TO: T10 Membership
FROM: Paul A. Suhler, Quantum Corporation
DATE: 21 January 2009
SUBJECT: T10/08-409r6, ADT-2: Internet ADT (iADT)

Figure 34 — Example Media Changer application of ADT

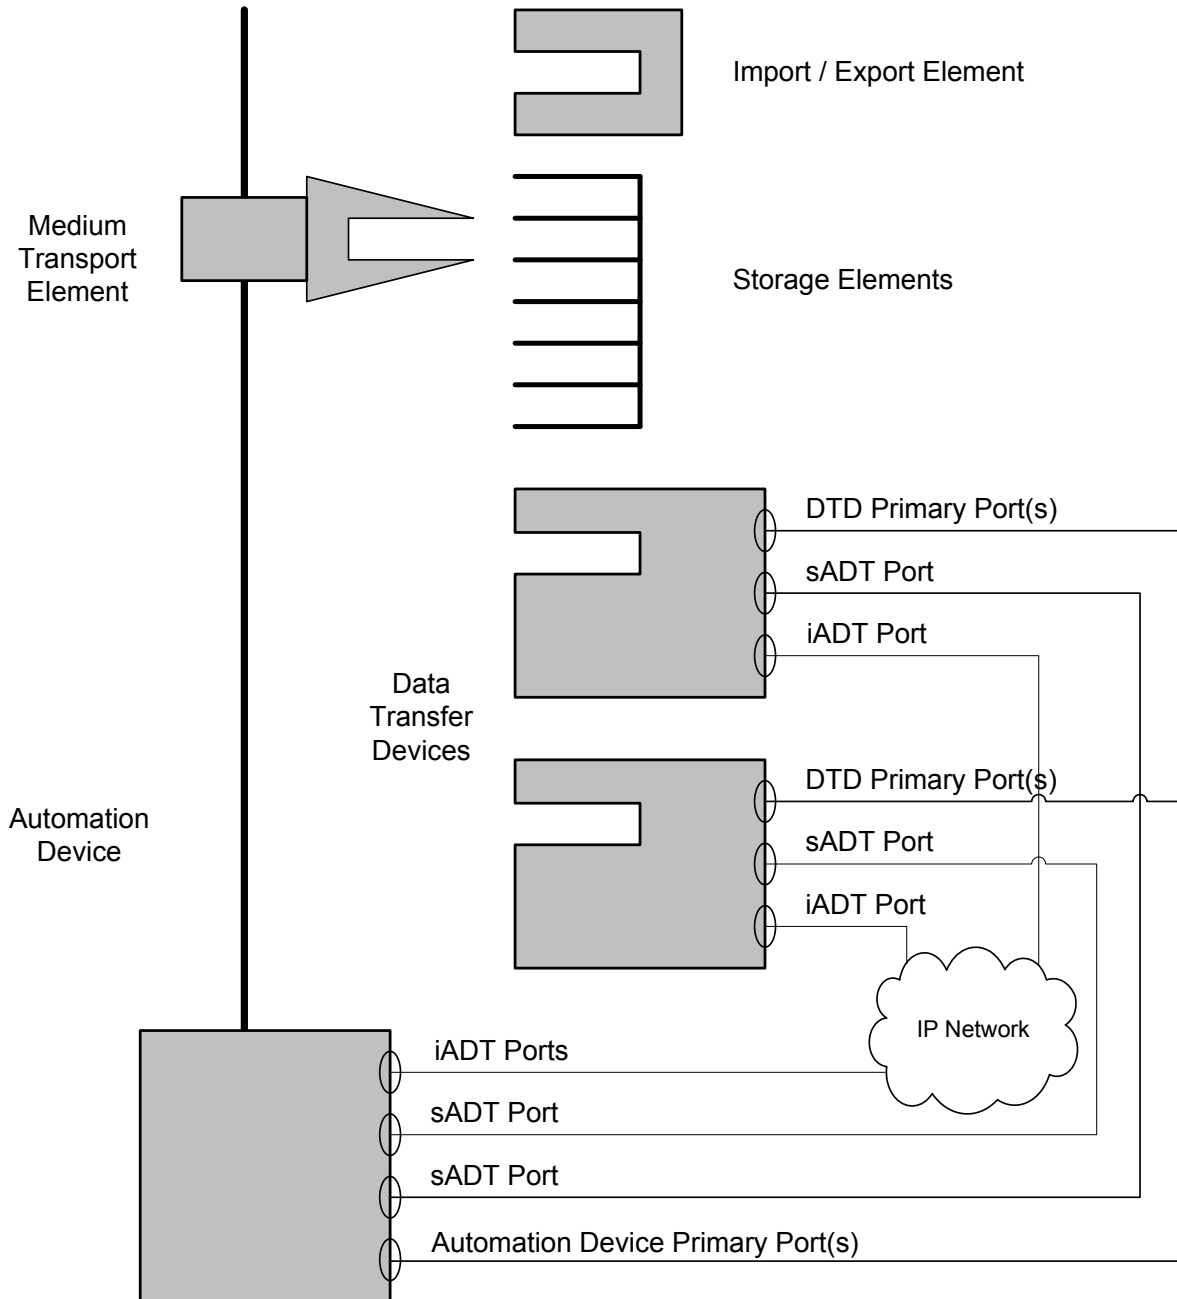
Figure 3 4 shows ~~an example of an ADT interface~~ examples of serial ADT (sADT) and internet ADT (iADT) interfaces (see 4.1.2) within a media changer containing two DT devices. Other common components of a media changer are also shown for reference. The components of an automation device are medium transport elements, data transfer (DT) devices, storage elements, and import/export elements (see SMC-3). The automation device may communicate with the DT devices through ADT ports, as defined in this standard. DT devices and automation devices communicate with initiator ports other than those in the automation device using primary ports.

Replace and renumber Figure 3:

4.3.2.5.2 Transition P3:Logged-out to P0:Initial

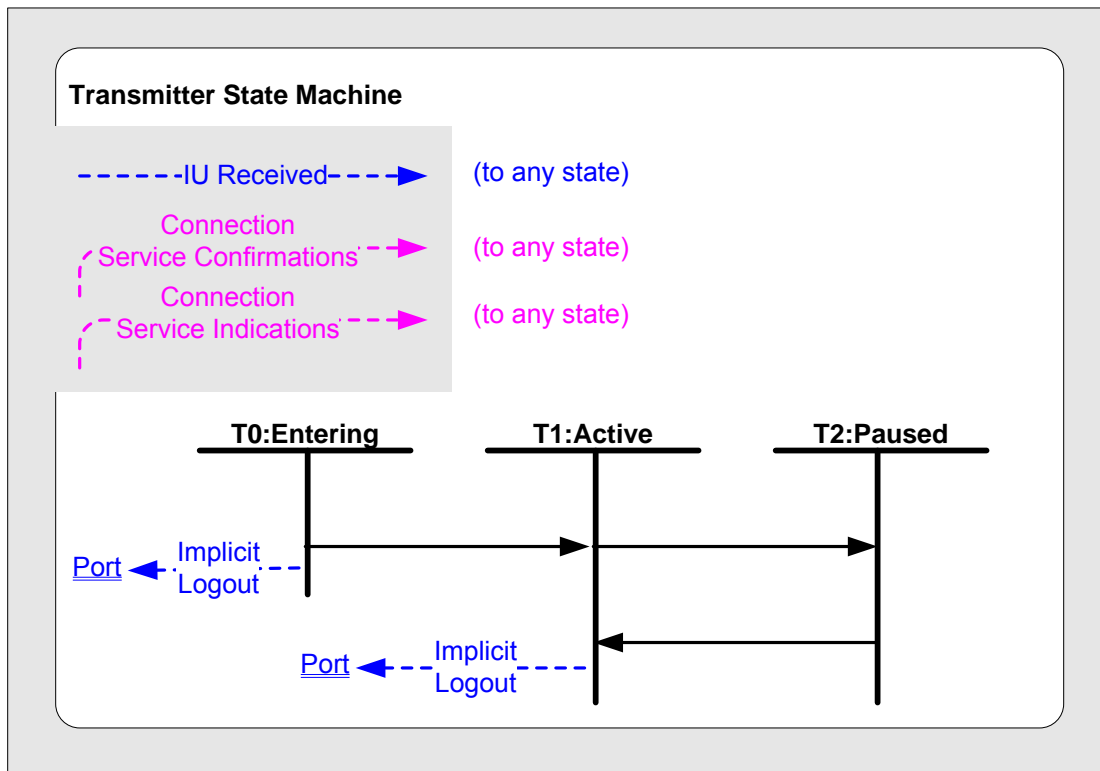
A port shall transition to P0:Initial after the logout duration time **specified in the Port Logout IU (see 6.5.5)** has expired.
